Site Accessibility Evaluation

Coroner's Office

**2741 E Las Vegas St
Colorado Springs, CO
80906**

***Inspection Date: 07/23/2019
Inspector: David Mejia***

Finding: 1

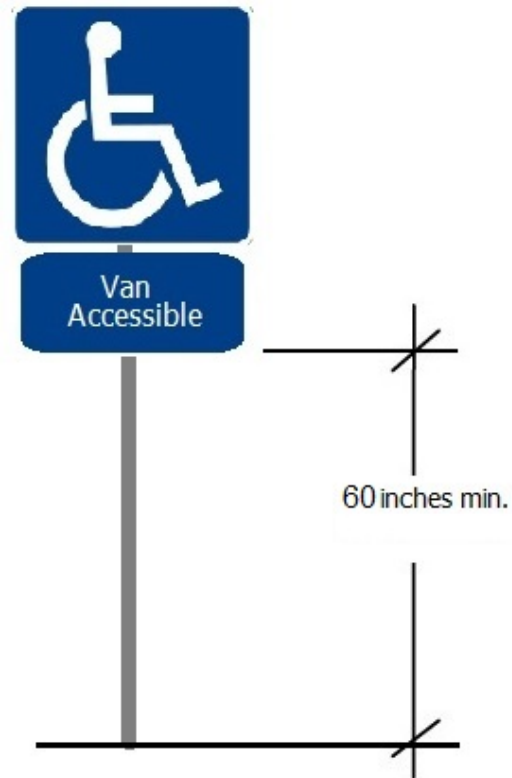
The parking sign is mounted too low.

43.5 inches above
finished floor

Adjust height to meet compliance no less than 60 inches from bottom edge of van accessible sign.

Finding: 2

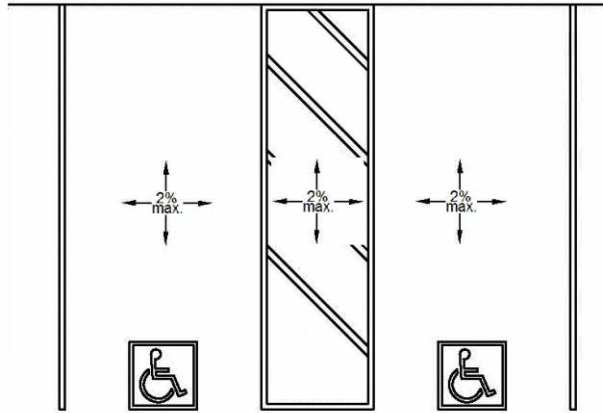
The cross slope (narrow dimension) of the parking stall exceeds 2%.

2.7% - 3.03% cross
slope

Re-pave existing parking stall and access aisle for cross slope and running slope not to exceed 1:48 / 2%.

Finding: 3

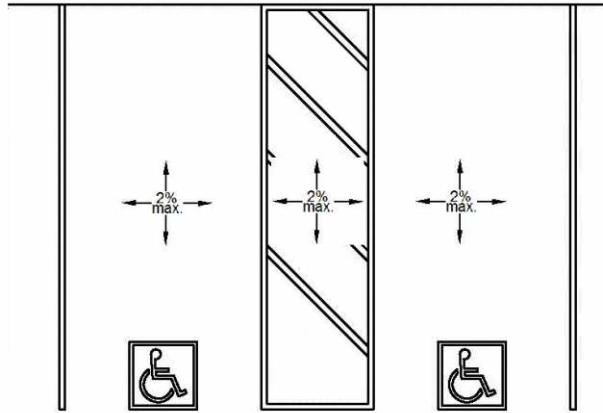
The cross slope (short dimension) of the access aisle exceeds 2%.

2.67% - 2.97% cross
slope

Re-pave existing parking stall and access aisle for cross slope and running slope not to exceed 1:48 / 2%.

Finding: 5

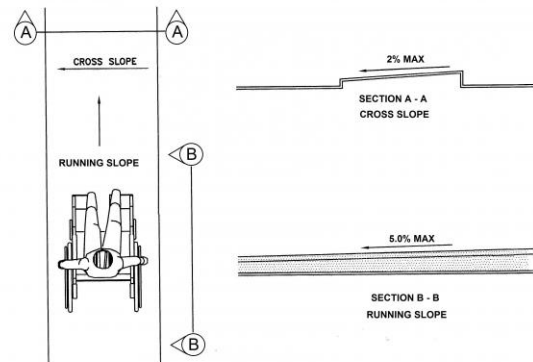
The accessible path of travel between the building entrance and the accessible parking contains cross slopes greater than 2%.

2.6% - 4.6% cross
slope

Re-pave existing path of travel for cross slope not to exceed 1:48 / 2%.

Finding: 6

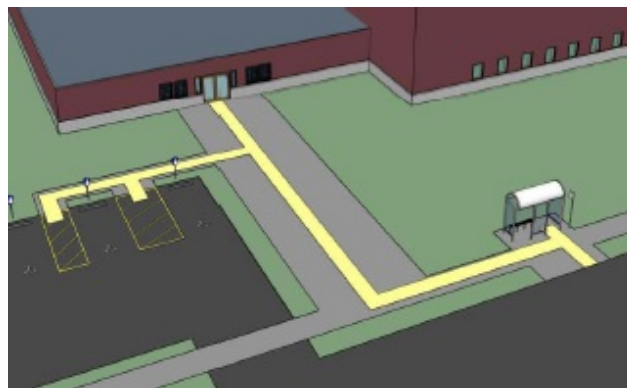
The accessible parking space is not located on the shortest accessible route to the building.

Accessible parking
stall and access aisle
furthest from building
entrance

Re-configure parking lot to provide accessible parking stall and access aisle on the shortest accessible route or post sign identifying parking lot as "coroner's employee parking only".

Finding: 7

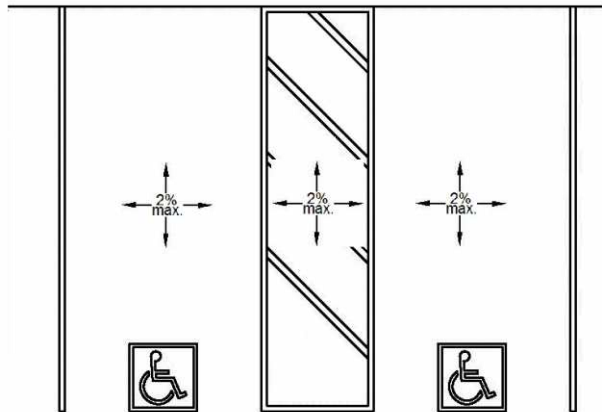
The cross slope (short dimension) of the access aisle exceeds 2%.

2.6% - 3.5% cross
slope

Re-pave existing access aisle located near front entrance of building for cross slope and running slope not to exceed 1:48 / 2%.

Finding: 8

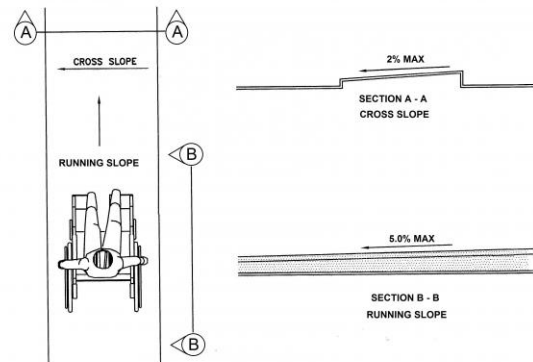
The accessible path of travel contains cross slopes greater than 2%.

2.6% - 3.5% cross
slope

Re-pave existing path of travel located near front entrance of building for cross slope not to exceed 1:48 / 2%.

Finding: 9

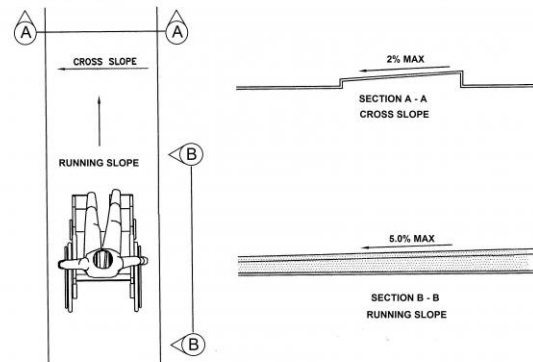
The accessible route on the site contains running slopes greater than 5% and has not been constructed as a ramp (i.e. handrails, wheel guides, etc.).

5.0% - 6.99% running
slope

Re-pave existing path of travel located near front entrance of building for running slope not to exceed 1:20 / 5%.

Finding: 10

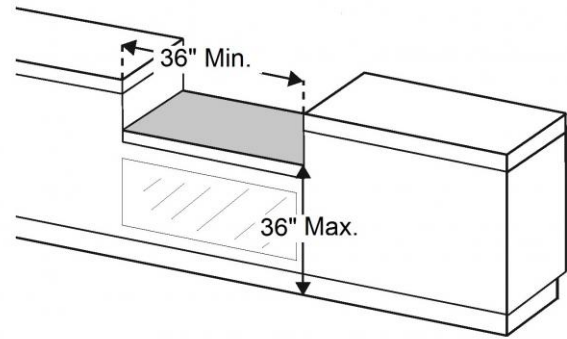
The transaction counter provides for a parallel approach but does not provide a minimum clear width of 36 inches.

39.25 inches above
finished floor

Replace or re-configure a section of the transaction counter to provide a clearance of 36 inches high and a minimum of 36 inches wide.

Finding: 11

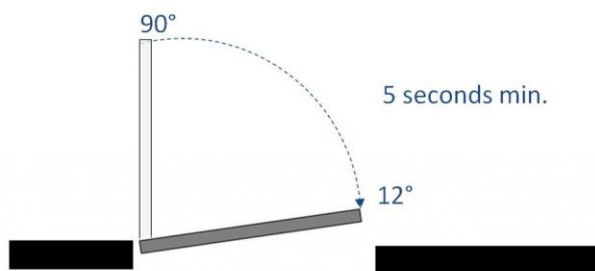
The door is equipped with a door closer and returns to a closed position too quickly.

4 seconds to closed position

Re-adjust door closer so that closing speed is 5 seconds or more from an open position to a position of 12 degrees from the latch.

Finding: 12

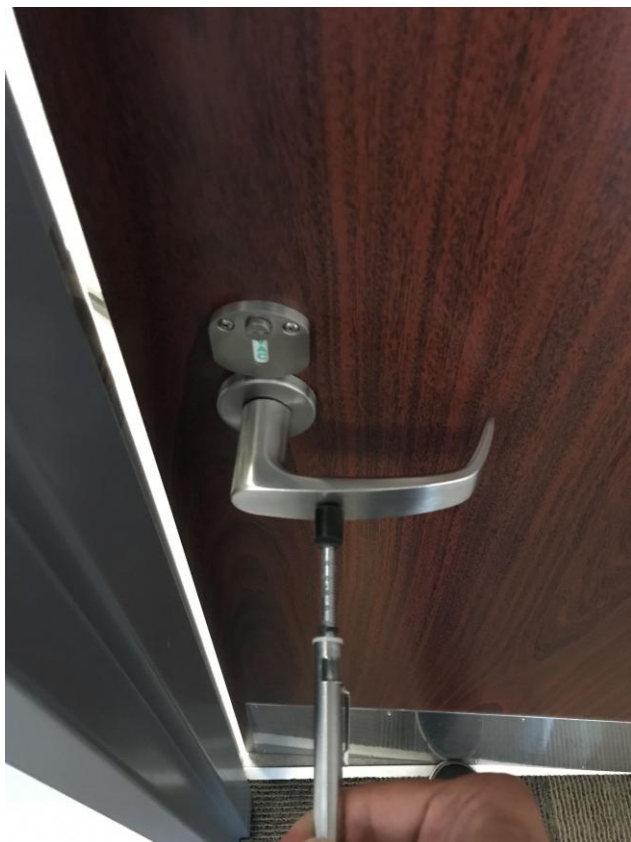
The door exceeds the maximum pressure to open the door.

8 lbs of force required

Adjust door hinges/opener so that the force needed to open door does not exceed more than 5 lbs of force to open.

Finding: 13

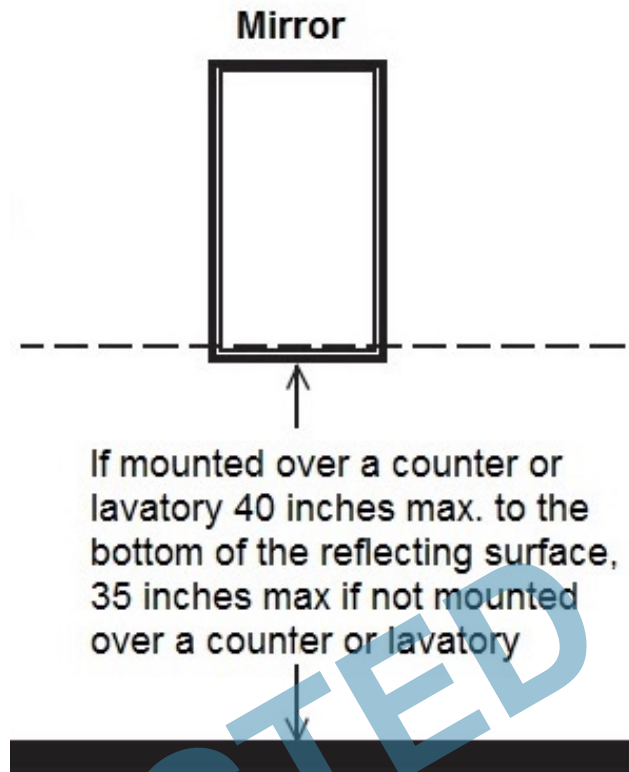
The mirror is mounted too high.

40.75 inches above
finished floor

Re-adjust mirror so that reflective surface of mirror does not exceed 40 inches above finished floor.

Finding: 14

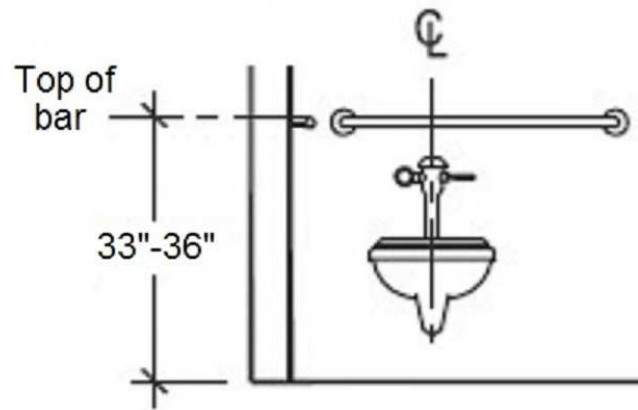
The rear grab bar is too high.

36.5 inches above
finished floor

Re-adjust grab bar so that top of the gripping surface does not exceed 36 inches maximum.

Finding: 15

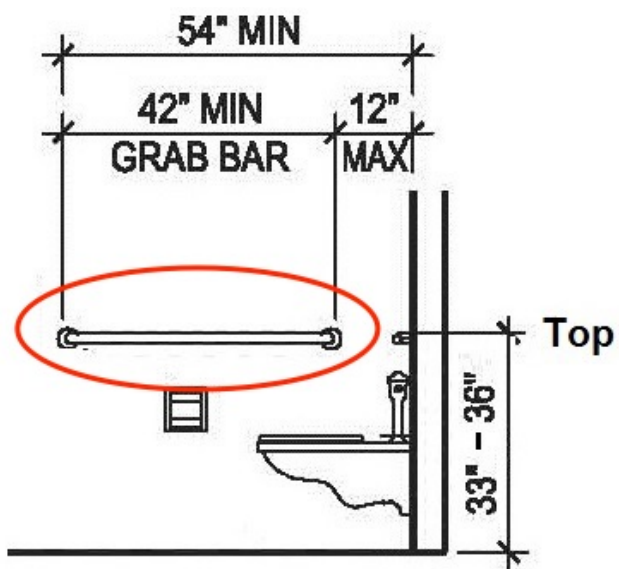
The side grab bar is too high.

36.5 inches above
finished floor

Re-adjust grab bar so that top of the gripping surface does not exceed 36 inches maximum.

Finding: 16

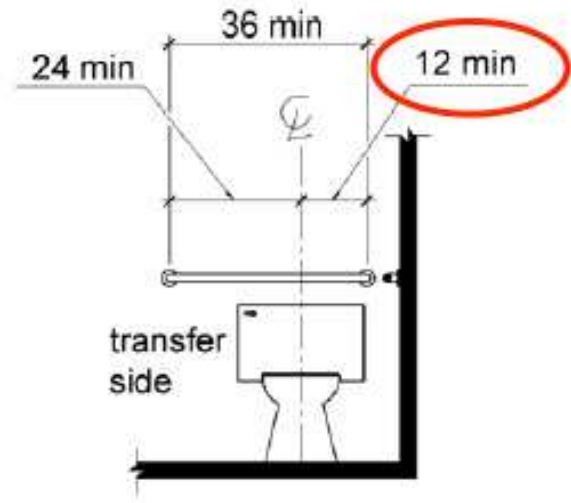
The rear grab bar does not extend adequately past the centerline of the toilet on the wall side.

11 inches from wall
side

Re-adjust rear grab bar to extend 12 inches minimum from centerline of toilet on wall side and 24 inches minimum on transfer side.

Finding: 17

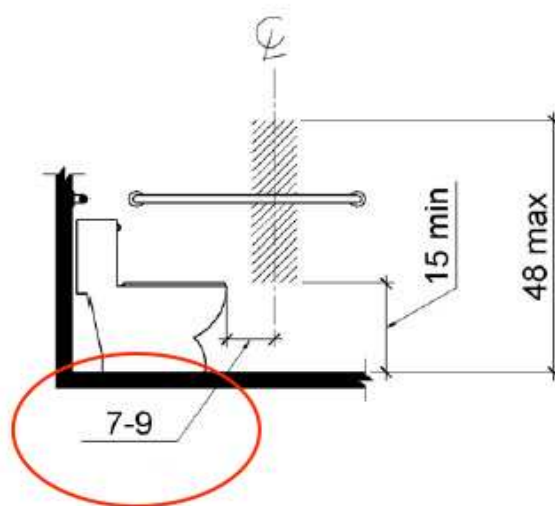
The toilet paper is not installed within the compliant range in front of the toilet.

13 inches in front of toilet

Re-adjust toilet paper dispenser 7 inches minimum and 9 inches maximum in front of toilet measured to the centerline of the dispenser.
